PLANNING AND ZONING COMMISSION
Regular Meeting
Monday, March 14, 2016

SUBJECT: Consider recommending approval of PZ Case 16-04, Wilkie Addition Preliminary plat. This plat subdivides 9.72 acres into 27 lots and 2 outlots. The subject property is located at the corner of NW 64th place and NW 51st Street.

RE: Wilkie Addition Preliminary Plat

RE: Wilkie Addition Preliminary Plat
Development Review 2
Case No. PZ 16-04

PRELIMINARY PLAT WILKIE ADDITION SHEET 4 OF 4

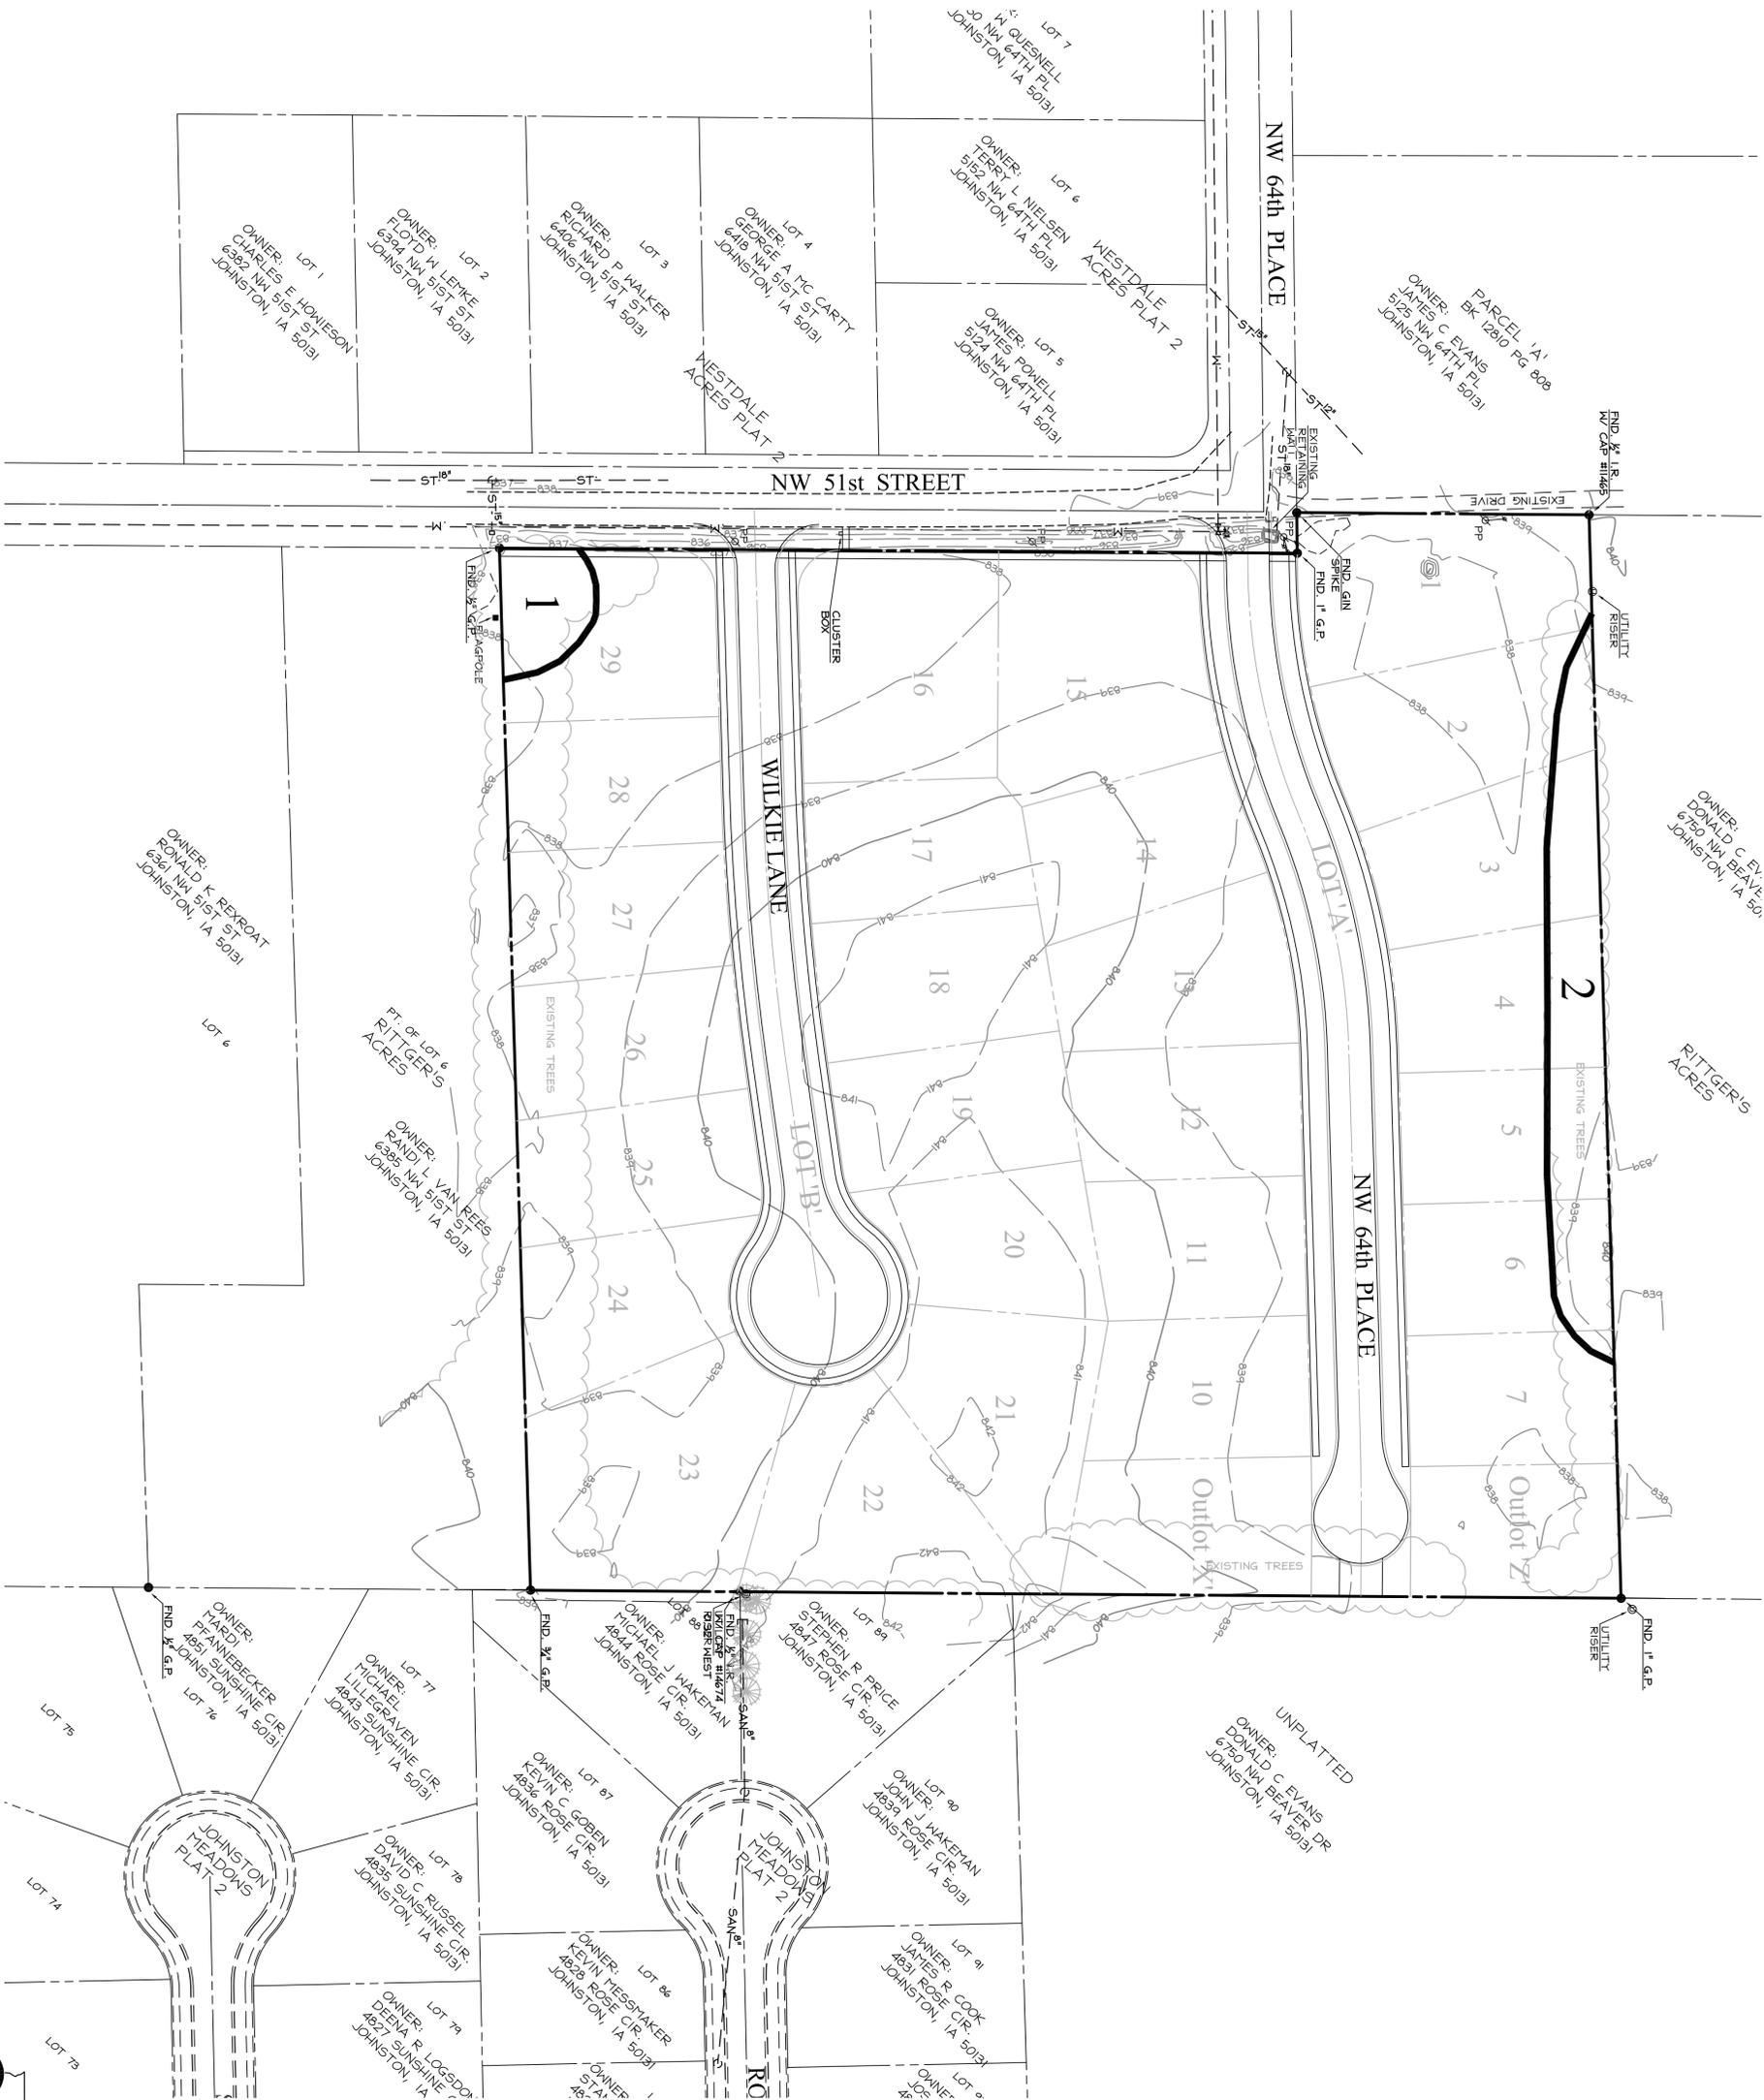
Since this property has been used for agriculture proposes tree removal will be limited. There are two areas of tree removal. In total 9 trees with a diameter greater than 6 inches will be removed.

12. Include an inventory of all trees greater than 6 inches in diameter to be removed.
13. Future lots 8 and 9 should be plated as outlots.
14. The temporary cul-de-sac on NW 64th place will need to be paved.
